AERONAUTICAL CHARTING FORUM
Instrument procedures Group
April 29-30, 2002
HISTORY RECORD

FAA Control # 02-01-240

Subject: ICAO Holding Pattern Safety Issue

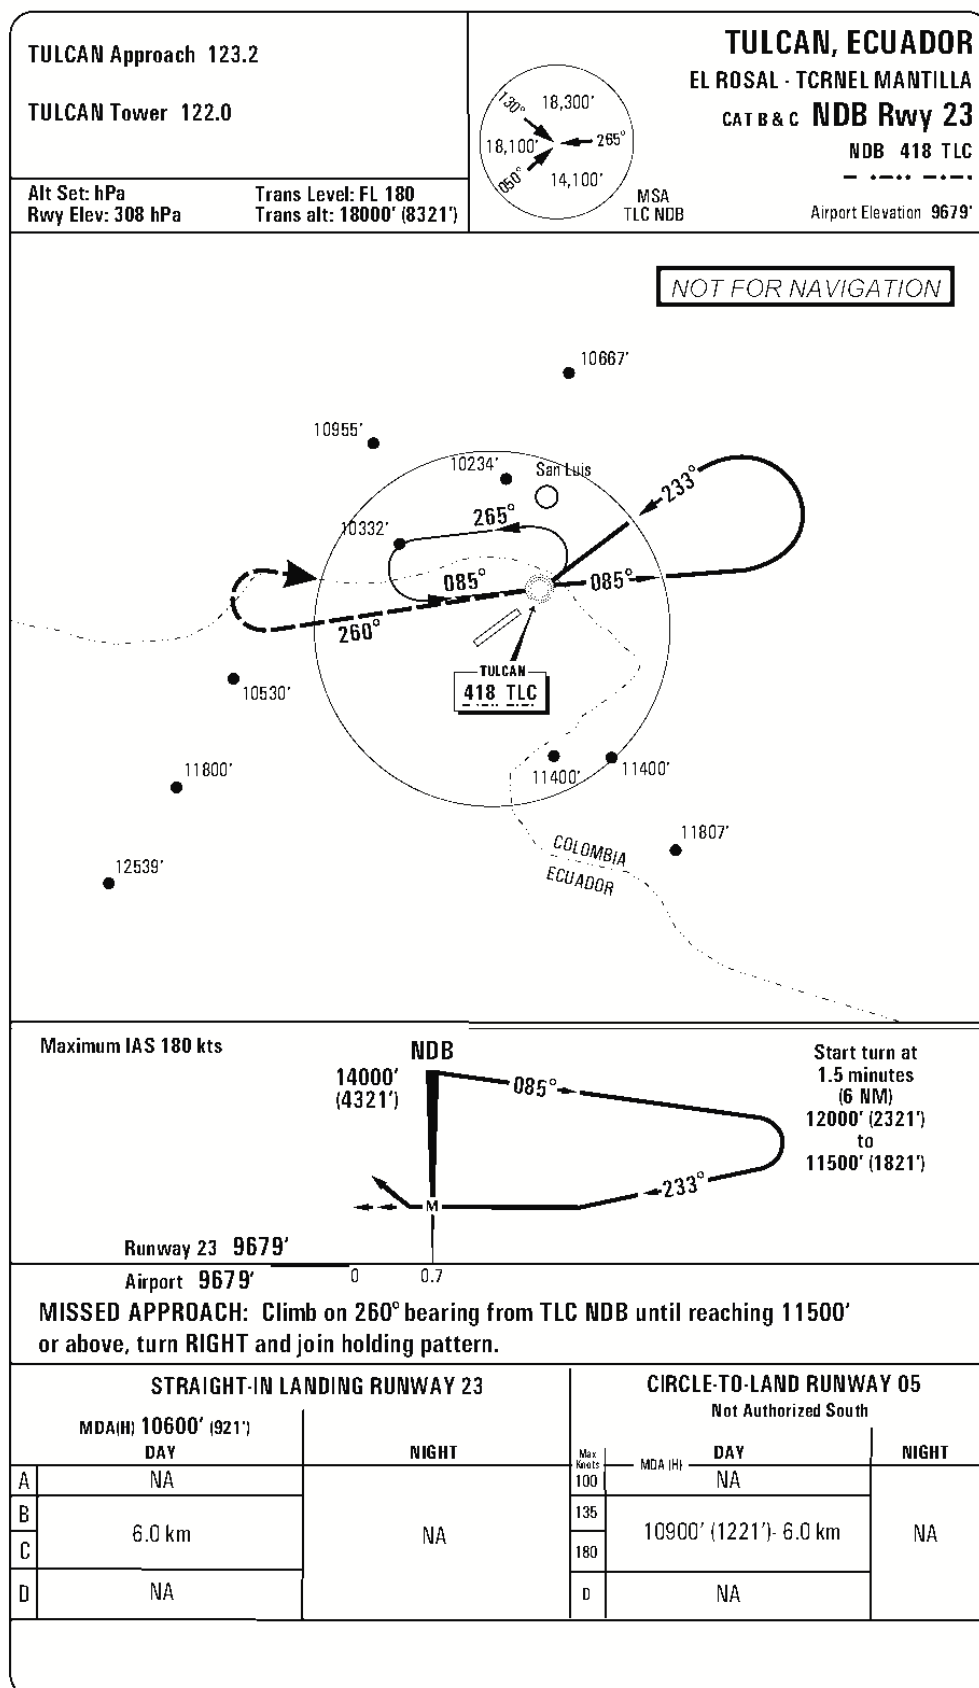
On the attached pages are a generic graphical representation of the Tulcan NDB IAP as it appeared on the date of the accident, as well as graphics of the topography for the area with placement of TERPS 230 and 175-knot holding templates for 14,000 feet. Note that the only reference to a speed limit is in the profile view of the approach chart, which most pilots would associate with the base leg outbound as shown in the profile view. Note also there is no minimum holding altitude shown in the plan view.

Recommendation: That this forum initiate the necessary actions to cause the United States representatives to ICAO to modify PANS-OPS holding pattern criteria and associated procedural text to: 1. Deny construction of holding patterns for jet airplanes with speeds less than standard, for altitudes above 10,000 feet. For altitudes 10,000 feet, and below, and where an operational requirement exists, deny a speed reduction for jet airplanes of less than 200 knots. Where a unique requirement exists for lower speeds, such IAPs should not be issued to the public; rather they should be similar to our "specials" and issued only to carriers with a demonstrated need and proven qualifications. 2. That PANS-OPS be clarified to require any non-standard holding speed limit to be associated directly with the holding pattern's plan view icon (and in the profile view as well where an affected holding pattern is charted in the profile view. 3. That PANS-OPS be clarified to require the charting of the minimum holding altitude in a clear and unmistakable manner adjacent to the holding pattern icon.

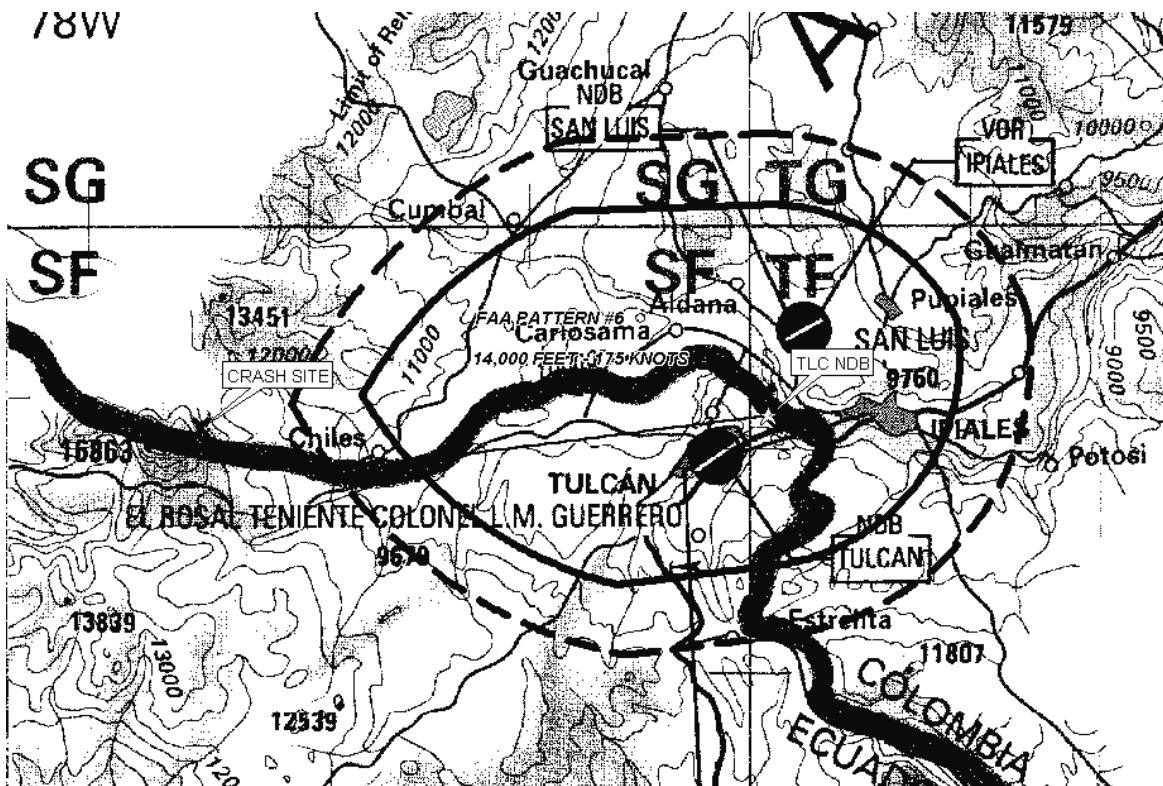
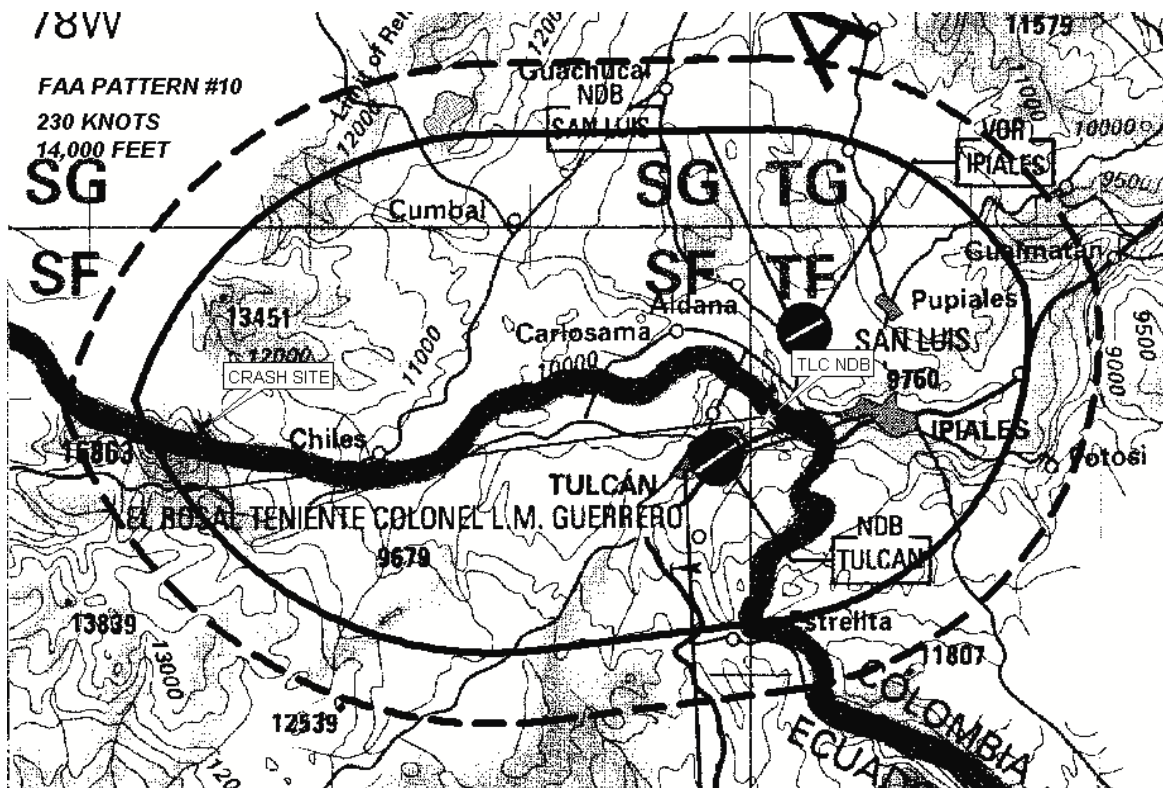
Apparently, the designer of the Tulcan NDB IAP elected to constrain the holding pattern to 180 knots, with a minimum holding altitude of 14,000 feet. In the United States, such a pattern would have to be the standard 230-knot pattern to be authorized for jet airplanes. These United States criteria are based on valid aerodynamic premises. It appears that PANS-OPS terminal instrument criteria are open to more conjecture, at least as to holding pattern design, than are U.S. TERPs. It is apparent, though, that the standard application of PANS-OPS criteria would have dictated a 240-knot pattern at Tulcan above 14,000 feet, and a 230-knot pattern at 14,000 feet.
